SERVICE BULLETIN

SUBJECT: TS-520S -6V DC SUPPLY FAILURE

DATE 8/9/79

BOTTOM SIDE

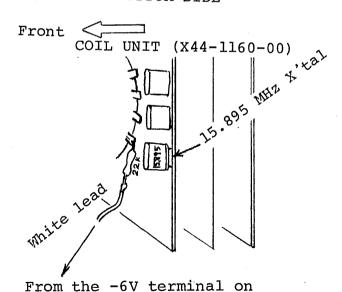
When troubleshooting a TS-520S, check all power supply voltages, including the -6V DC supply. Symptoms such as dead, blown 2A DC fuse and now dead, low RX, no TX, or similar may occur after switching between 80 & 40M.

Cause of failure may be traced to an intermittent shorting between the 14V DC & -6 DC supplies as the Band Switch is rotated between 40 & 80 M. This will weaken or destroy D8,6V Zener on the FIX CH AVR unit. To prevent repeat failure, break the WHITE lead & install a 22K ohm WW resistor at the Bandswitch S5-6, between the -6V supply line and switch terminal. And of course replace D8 on the FIX CH AVR unit, X43-1100-00.

New Part 22k ohm ⅓W
